**TOWN OF MOUNTAIN VILLAGE
REGULAR DESIGN REVIEW BOARD MEETING
AGENDA**

THURSDAY OCTOBER 1, 2020 10:00 AM

TO: Mountain Village Design Review Board
FROM: John Miller, Senior Planner
FOR: Design Review Board Public Hearing; October 1, 2020
DATE: July 23, 2020, *Updated September 18, 2020*
RE: Staff Memo – Final Architecture Review, Lot 630

1 PROPOSED SITE PLAN
SCALE: 1" = 10'-0"

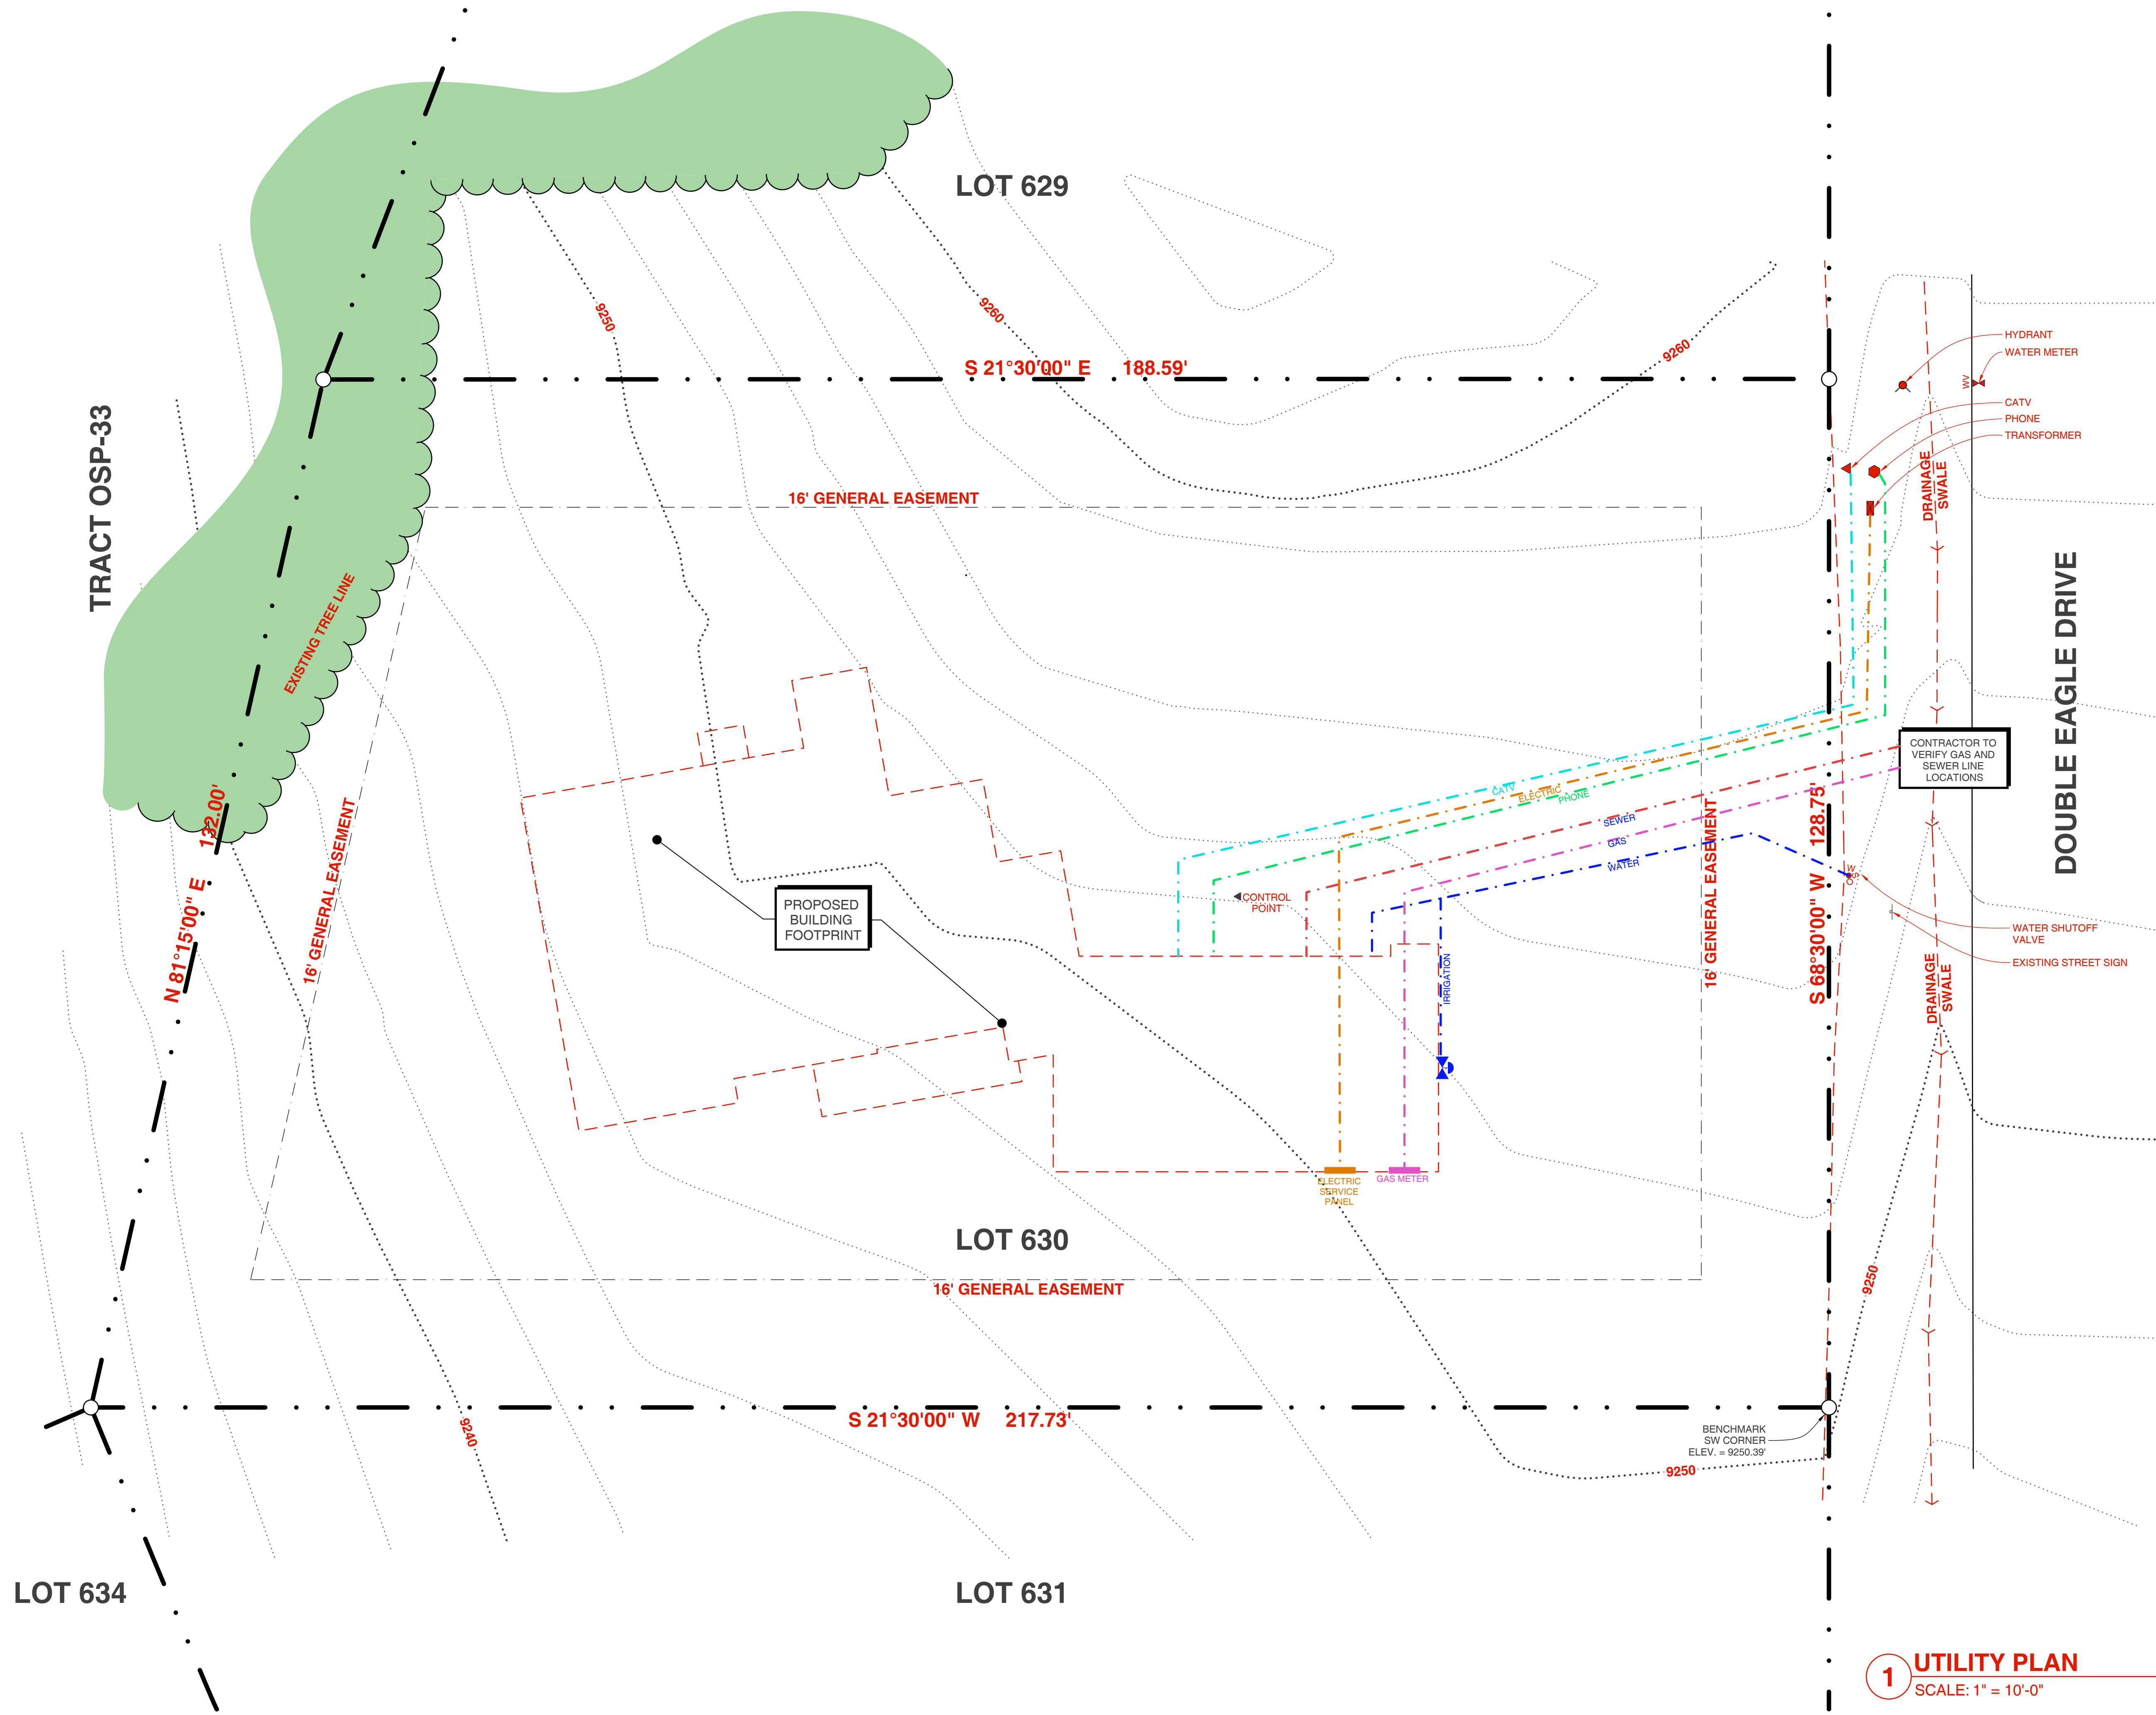
Staff: The applicant has revised the driveway plan to meet the CDC standards with 12 feet width and 2-foot shoulders on each side. The maximum grade of the driveway appears to be approximately 7% for a very short distance but overall, it ranges from 2-4% grade.

The driveway is 12'-0" wide and called out on the site plan and civil plan.

1 UTILITY PLAN
SCALE: 1" = 10'-0"

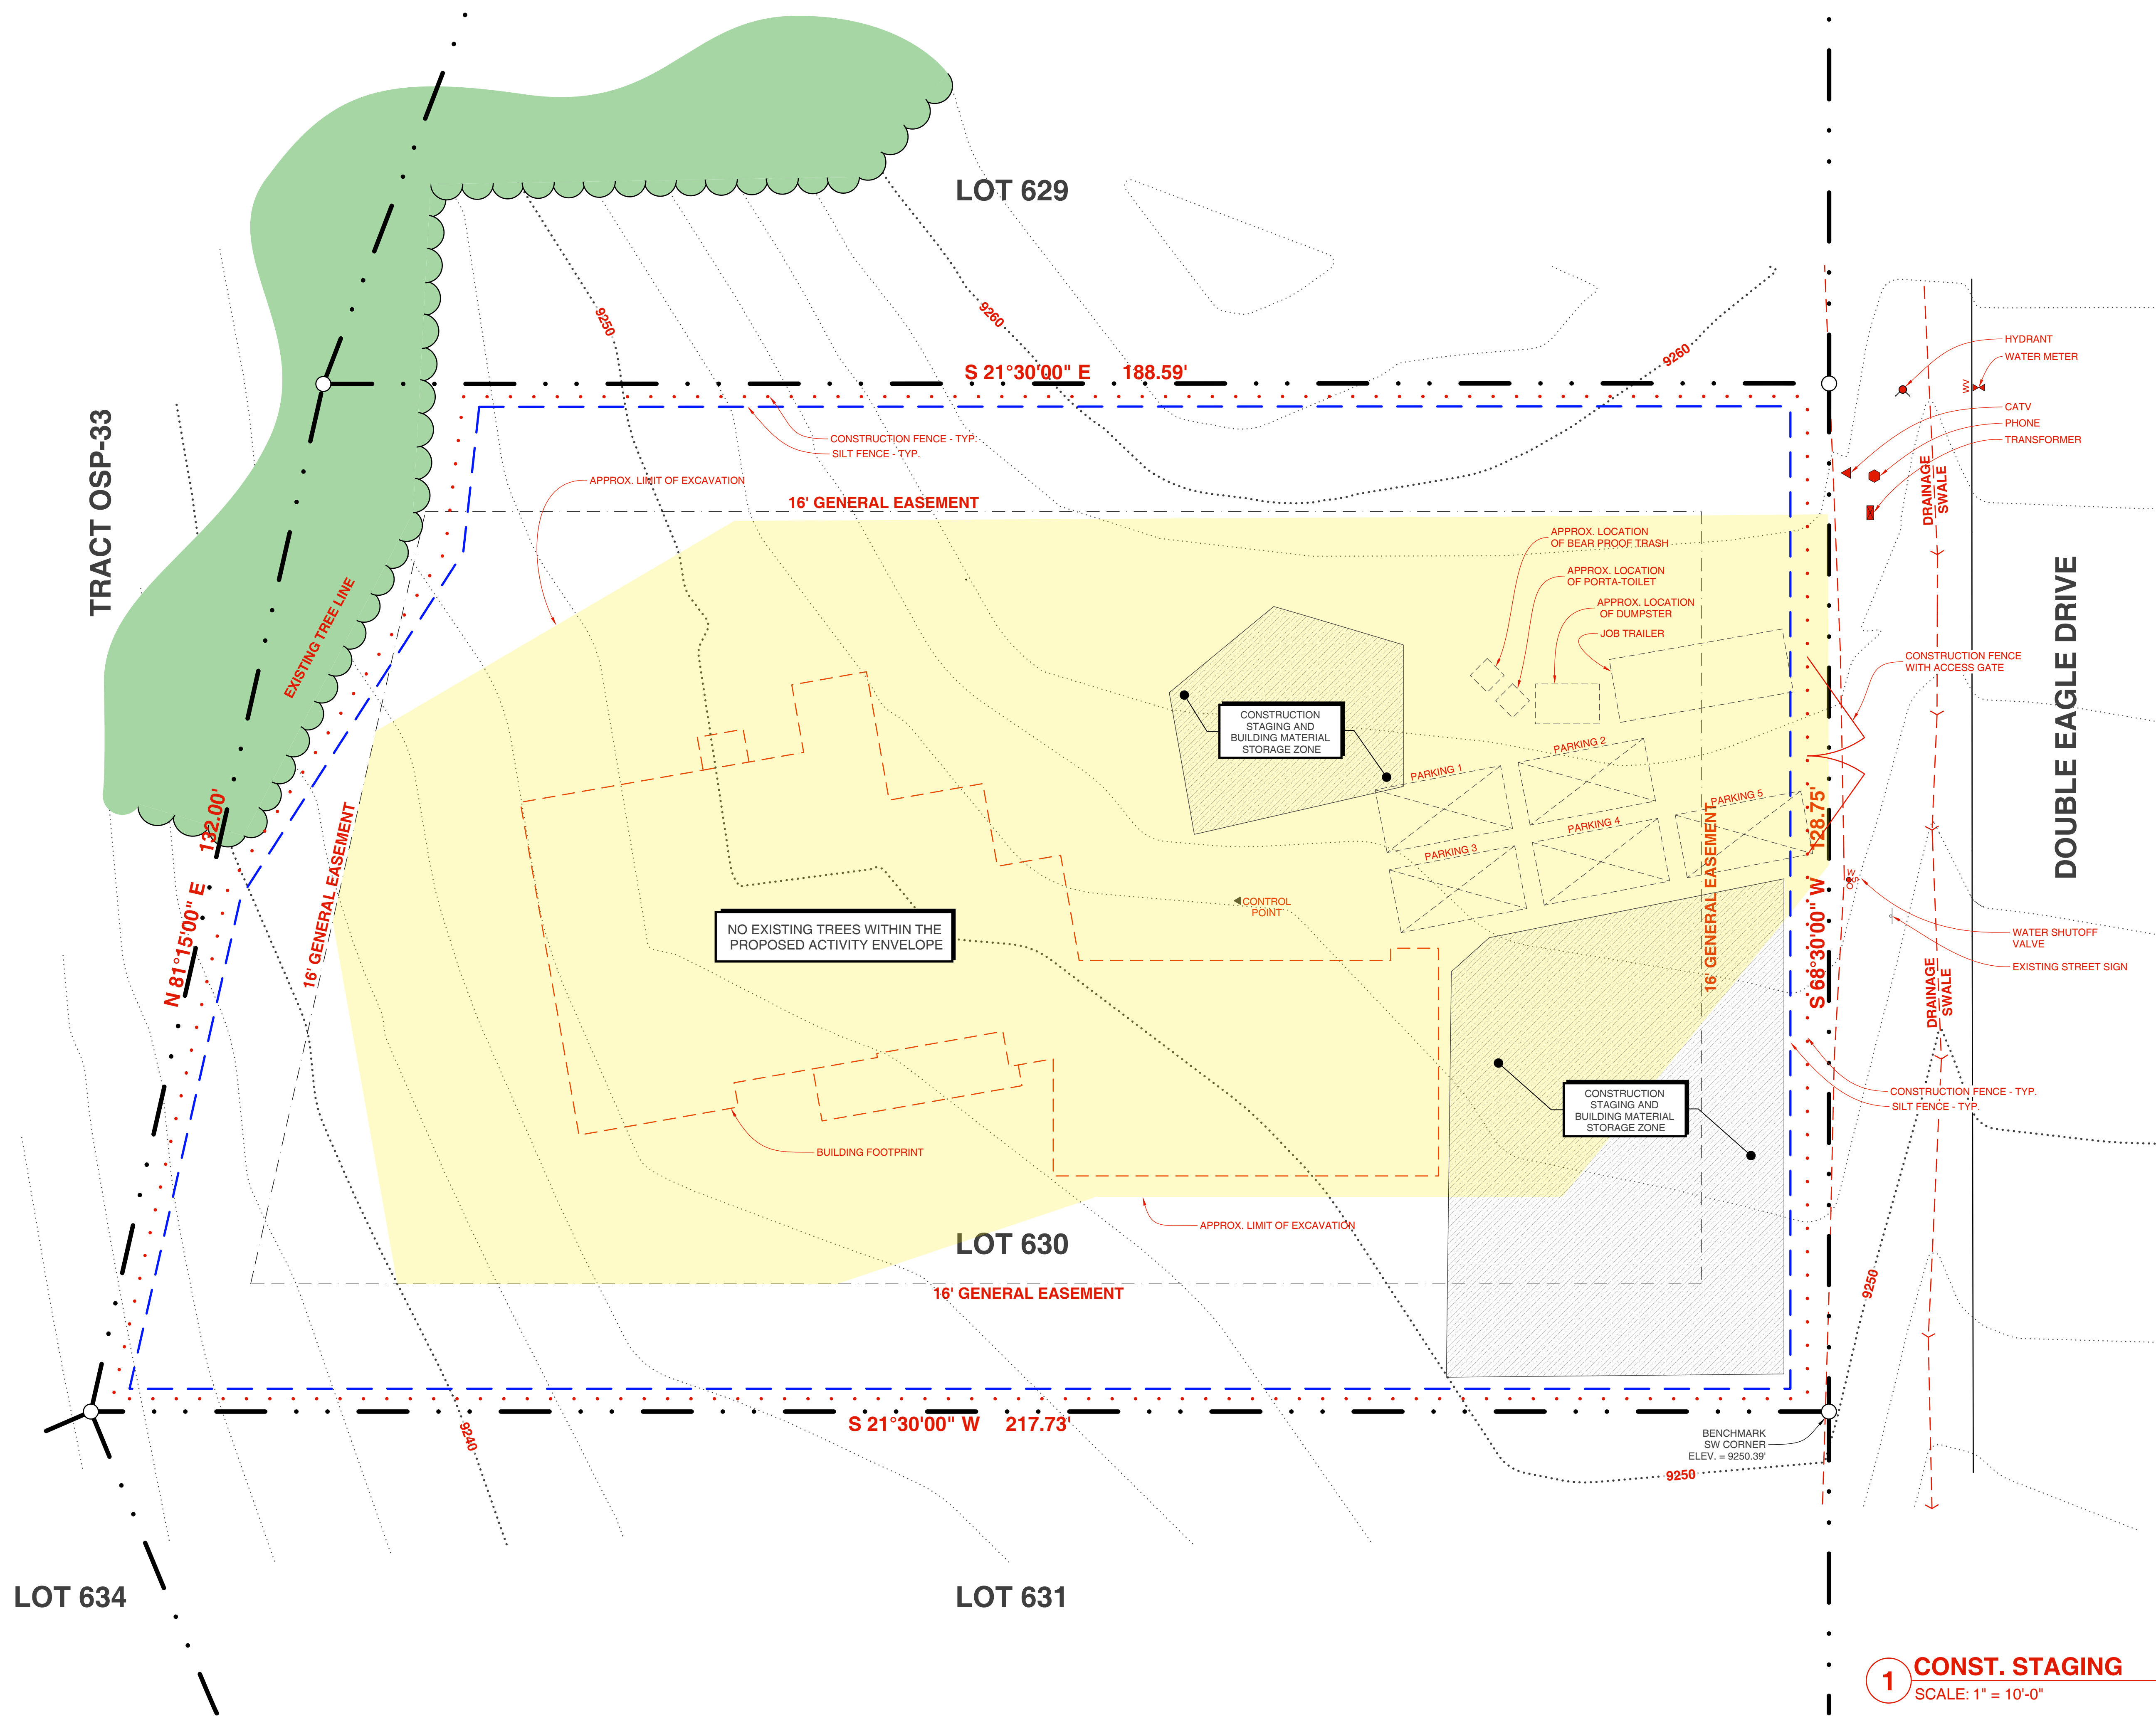
Staff: All utilities are currently located within the Double Eagle Drive roadway and will only require connections from the road to the home. The applicant shall work with the Public Works Director before the final review to determine the specific locations of the connections for the home. The plan set shows the proposed connections and the locations of the proposed utilities based on field research.

- 3) Prior to the issuance of a building permit, the applicant shall field verify all utilities and submit a revised utility plan to the public works director identifying the location of utilities and connection points.
